SERVICE BULLETIN

UTILITY TRAILER MANUFACTURING CO.

UTM Reference: SB-08-200 / 410219

Subject: BENDIX® SR-5 VALVE

Missing Radius on Valve Body

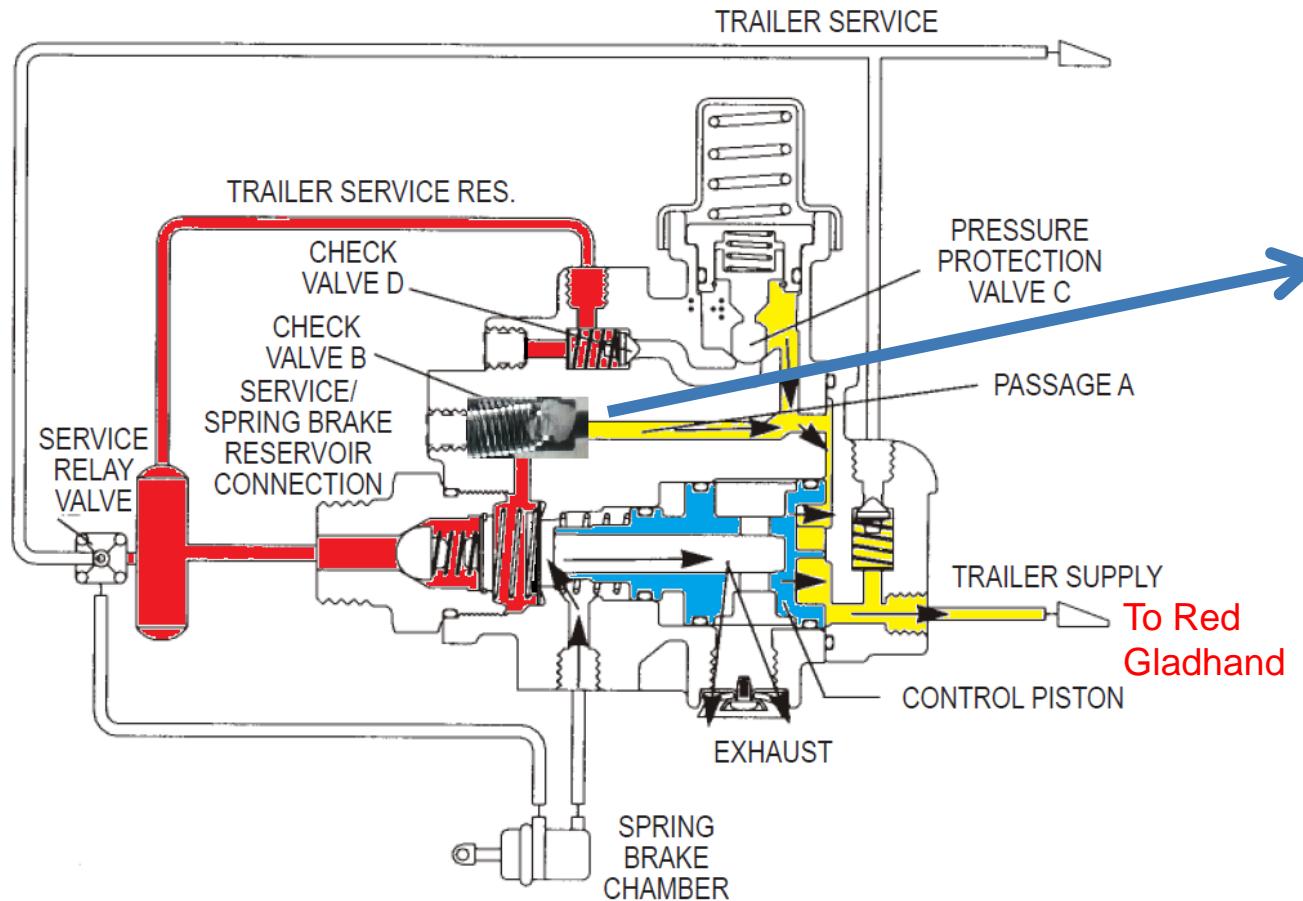
Missing Radius on Aluminum valve Body

When combined with certain field conditions – causes misalignment of internal Check Valve

Check Valve seat
(Radius Present / Radius Not Present)

If Valve becomes Misaligned, Leakage can be Large enough to cause 'Slow to Park'

Production Remedy - Re-introduce Radius on Valve Body (Began on Mar 4, 2016)

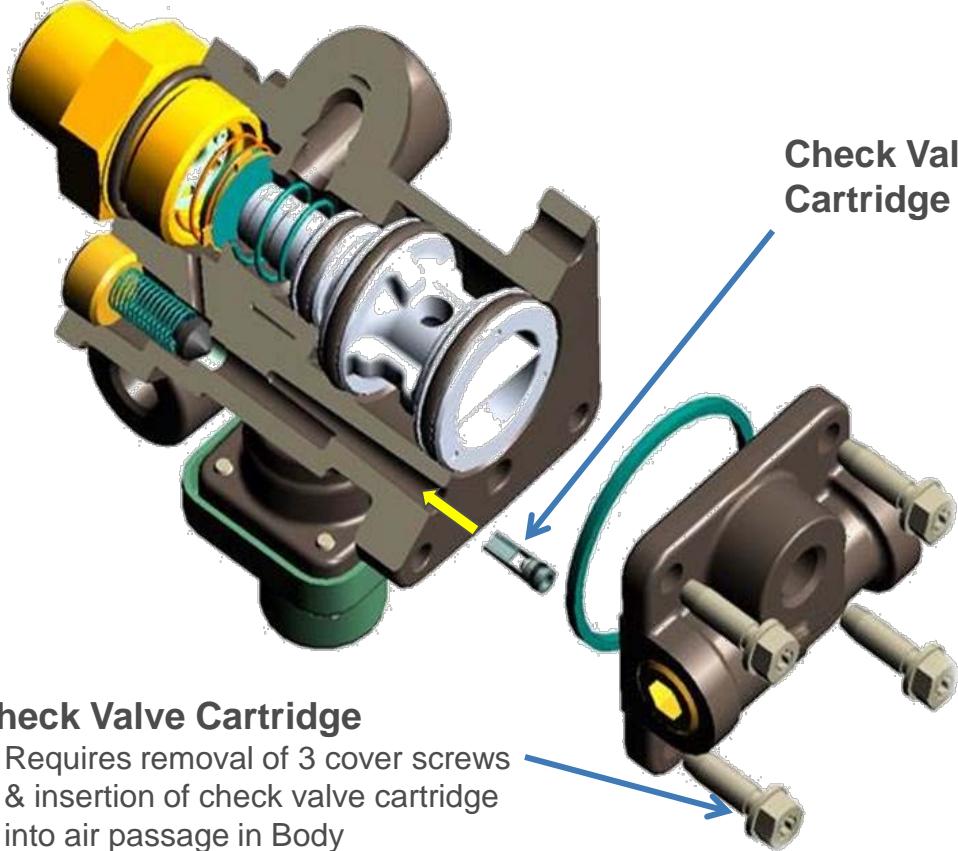
If Leakage is present (& large enough), the leaking air provides enough back pressure on the main control piston (BLUE) to prevent normal movement. If the main piston does not move, immediate exhaust (<3 seconds) cannot happen.

This is how the leakage from the check valve is causing the 'slow to park' condition.

Once leakage fully exhausts tank pressure, the backpressure drops, the main piston moves & the trailer parks.

Missing Radius (combined with other conditions) can cause leakage – preventing immediate parking

Check Valve Cartridge

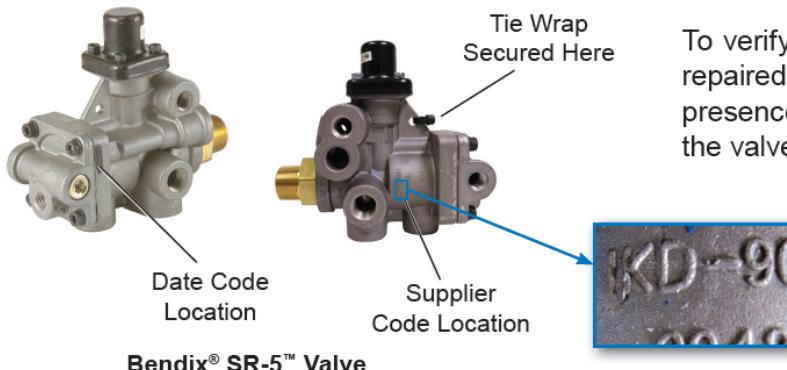
Field Remedy – Field Rework Procedure to insert a Redundant Check valve cartridge in air passageway. Procedure will not require removal & replacement of SR-5.

- Requires removal of 3 cover screws & insertion of check valve cartridge into air passage in Body
- Successfully remedied 100% of field returns w/ issue.
